THE COMMONS AT FALCON FIELD FILING NO. 1

CONSTRUCTION PLANS

EL PASO COUNTY FILE # SF2435

CONSTRUCTION DOCUMENTS FOR:
THE COMMONS AT FALCON FIELD
FILING No. 1
12445 RIO LANE, AND VACANT LAND
PEYTON, EL PASO COUNTY, COLORADO

STORM SEWER PLAN & PROFILE

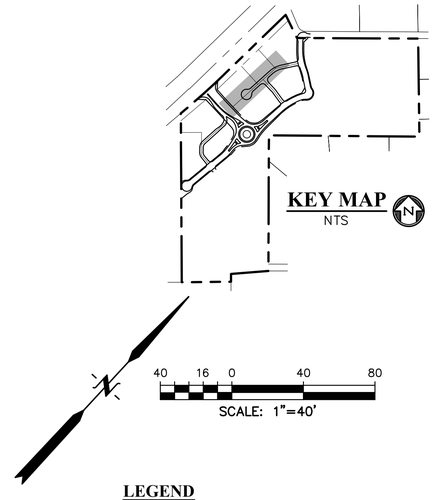
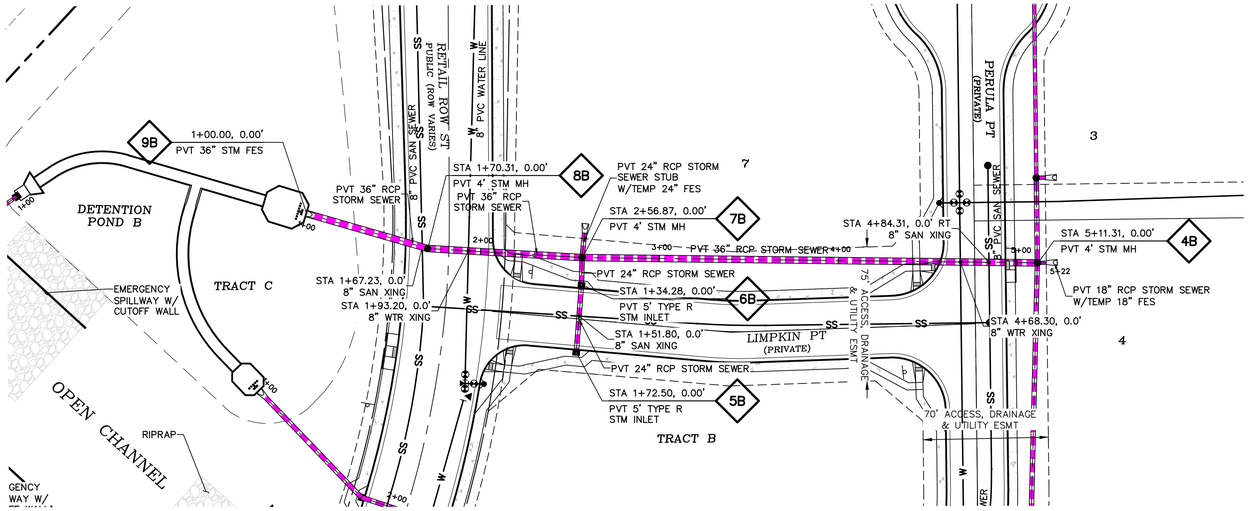
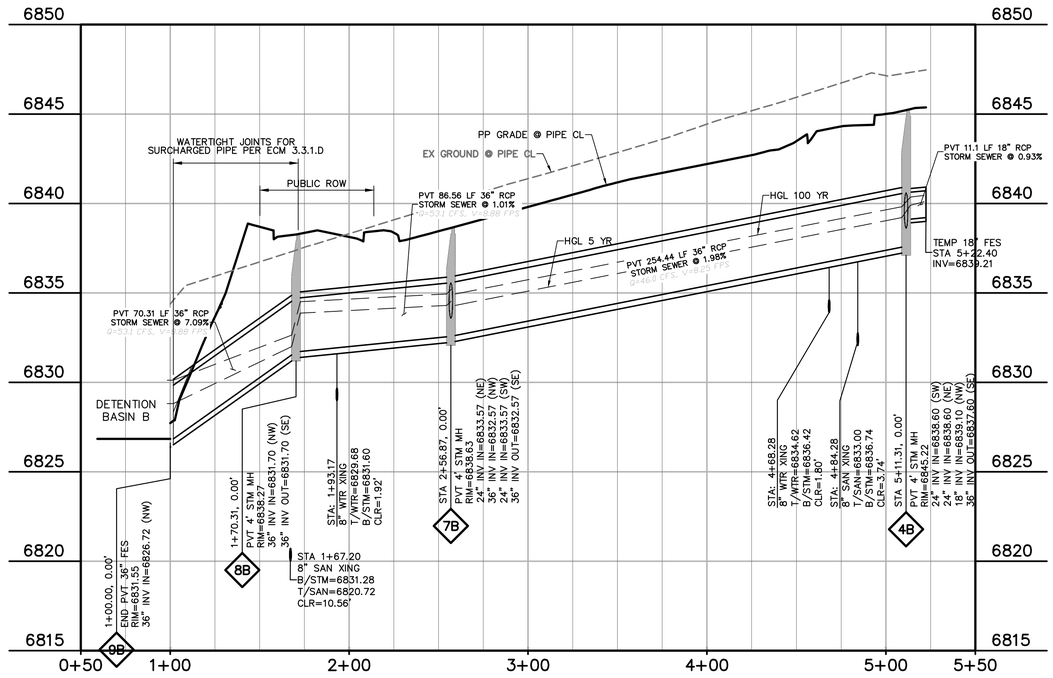
Due to groundwater, watertight joints should be considered for all storm pipes. Please be aware that storm system and associated roadways will not be preliminary accepted if groundwater is infiltrating the pipes. Similarly the box culvert should be protected from groundwater as that is a current issue with the box culvert at the Owl Place subdivision

SOUTH OUTFALL AND CHANNEL
1"=20'

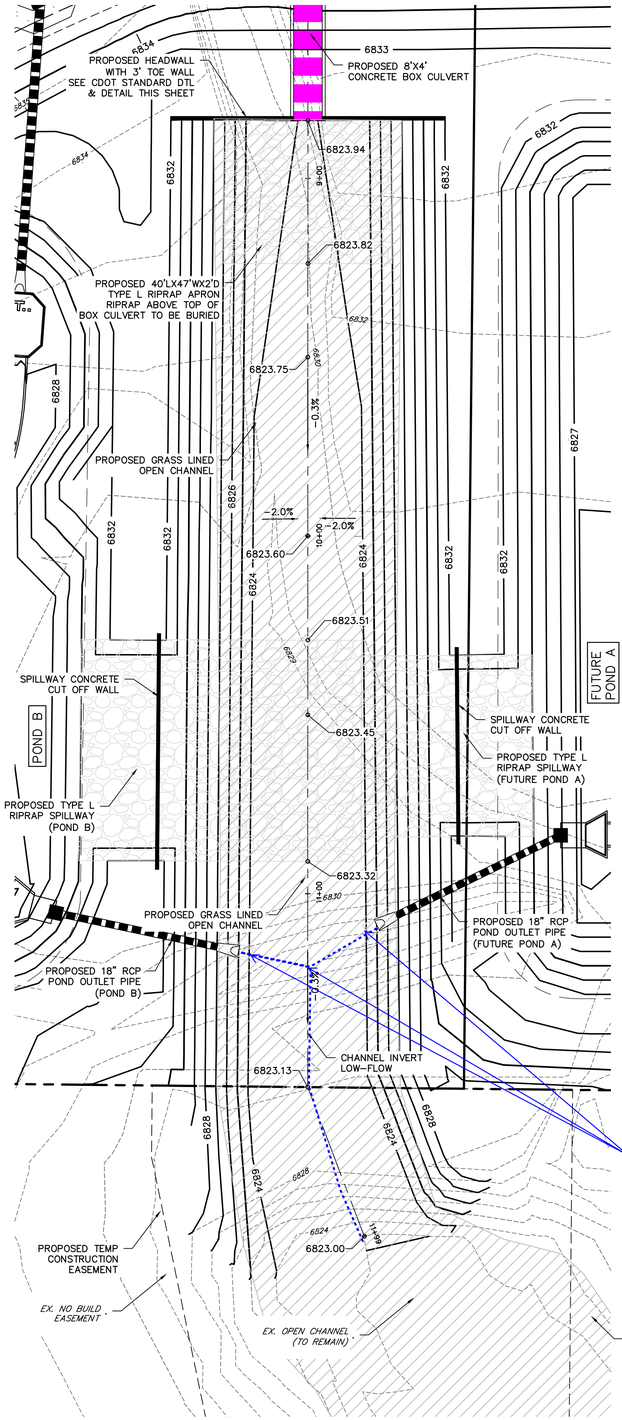
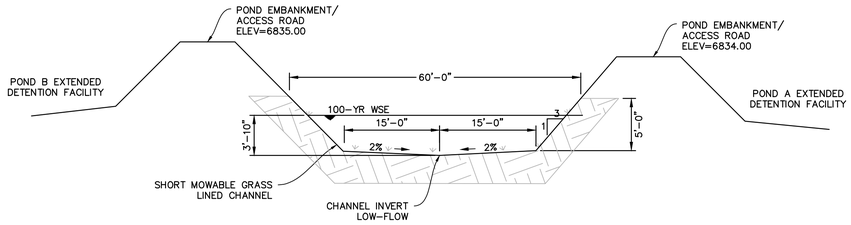
Unresolved: Label **all** low-flow inverts (may be "field fit" as applicable)
